### **STATION DESIGN AND PRECINCT PLAN – ARTARMON SUBSTATION**

The Artarmon Progress Association (APA) welcomes the opportunity to provide comments on the Artarmon Substation Design and Precinct Plan.

**Figure 5 – Illustration of Artarmon Substation at Barton Rd site – Chatswood to Sydenham  
May-June 2016 EIS summary**

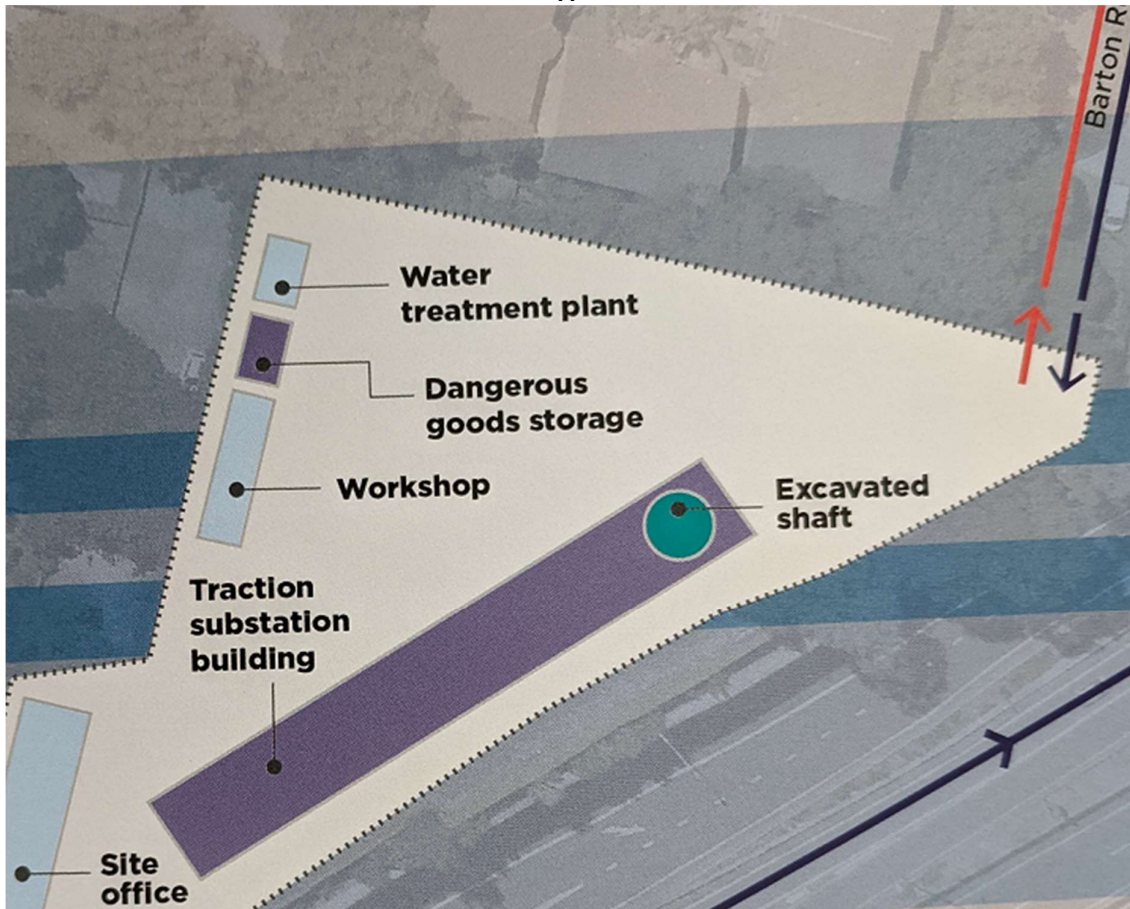
It is also out of character with the images of the substation as depicted in the Chatswood to Sydenham May-June 2016 Environmental Impact Statement Summary (EIS) (Figures 4 and 5). These figures show a well-designed single building with a sparse fence that cannot be used as a graffiti billboard.

If a fence is required it should be black with sparse railings, similar to the one included in the 2016 EIS Summary (Figure 5). Such fences are difficult to imprint an image or tag and are used for many TfNSW projects.

Figure 6 – Western Harbour Tunnel and Warringah Freeway Upgrade March 2020

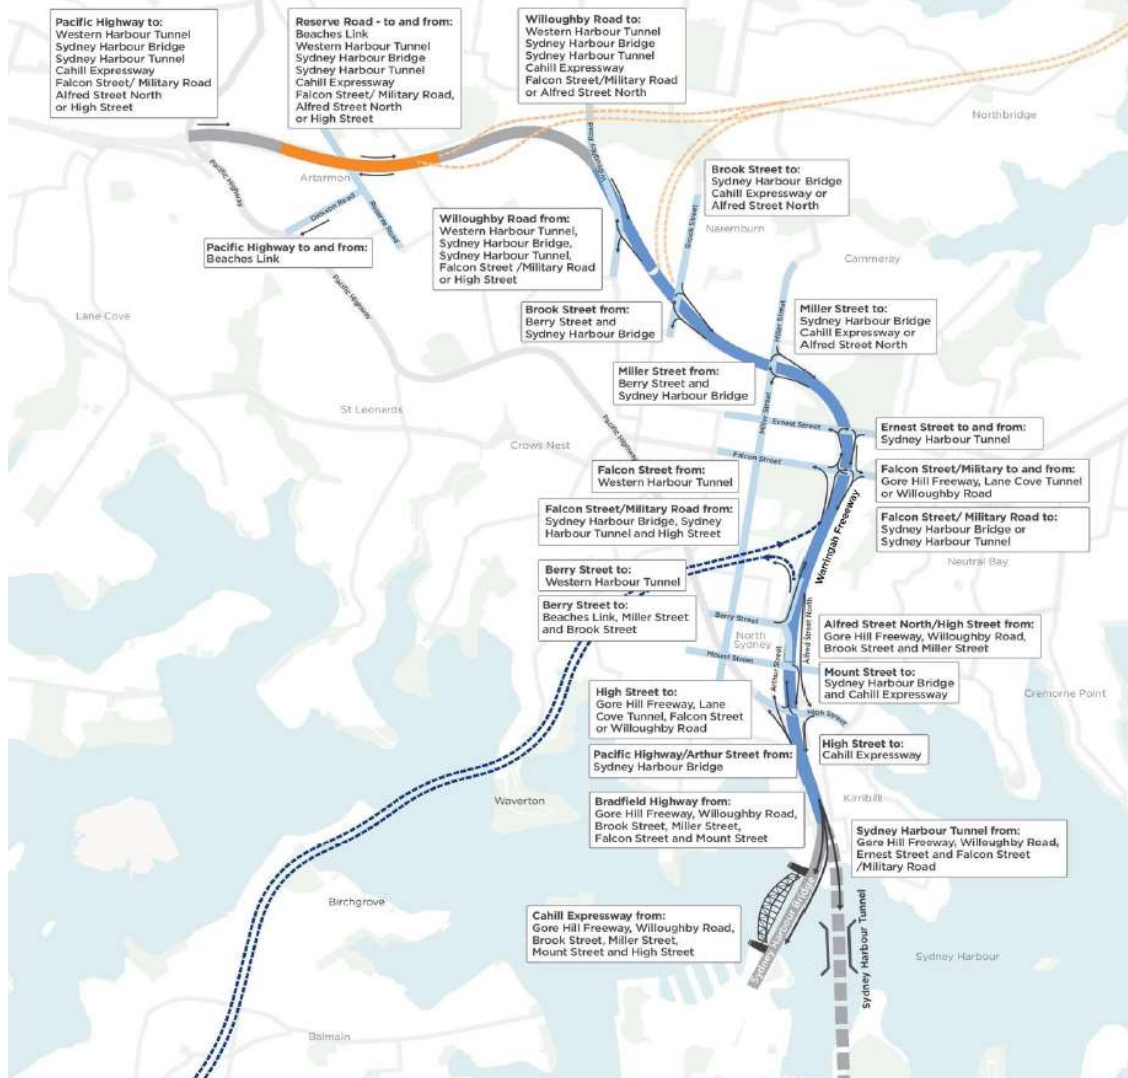
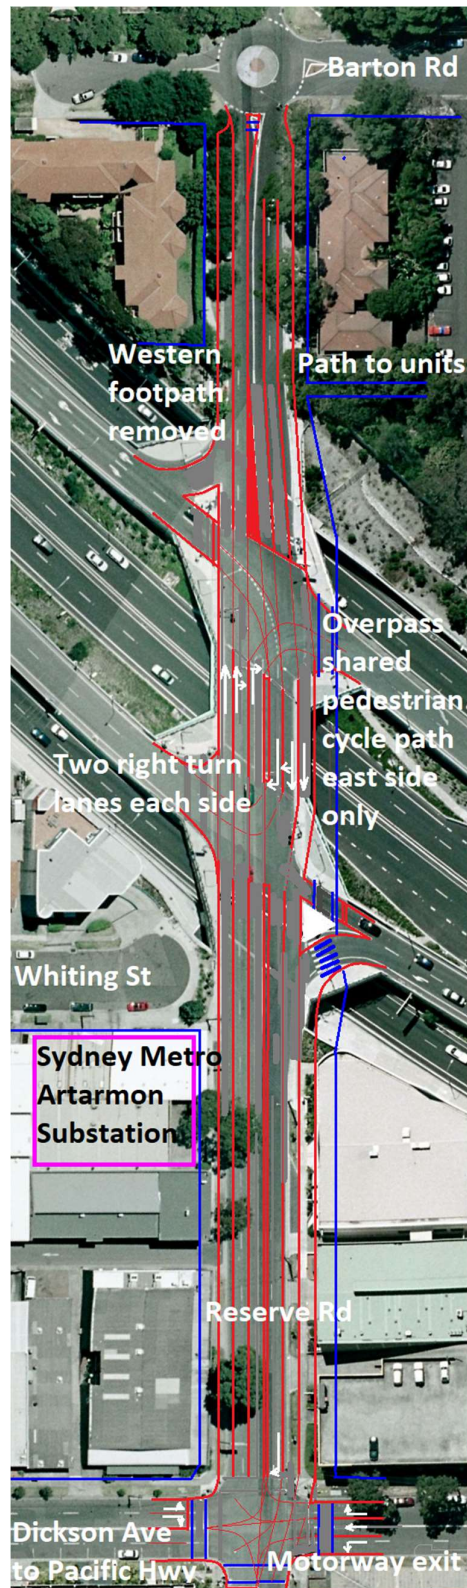
The Station Design and Precinct Plan (SDPP) was completed on 30 April 2017, three years before the “Western Harbour Tunnel and Warringah Freeway Upgrade March 2020” illustration (Figure 6) was released by TfNSW.

The substation plan has not been updated to eliminate the conflict which otherwise reduces the Reserve Road footpath width from 3.66 metres to 1.86 metres.

- The Western Harbour Tunnel EIS Appendix F Technical working paper: Traffic and transport (see extracts in Appendix 1) says the Reserve Road motorway overpass will be widened to 6 lanes using the bridge footpaths (each 1.8 m wide). The overpass will need widening on its eastern side for an extra road lane and pedestrian-cycle path.

As the substation will be there for at least a century, provision needs to be made for the road widening whether it proceeds with the Beaches Link project, or not, due to the current congestion of Reserve Rd.
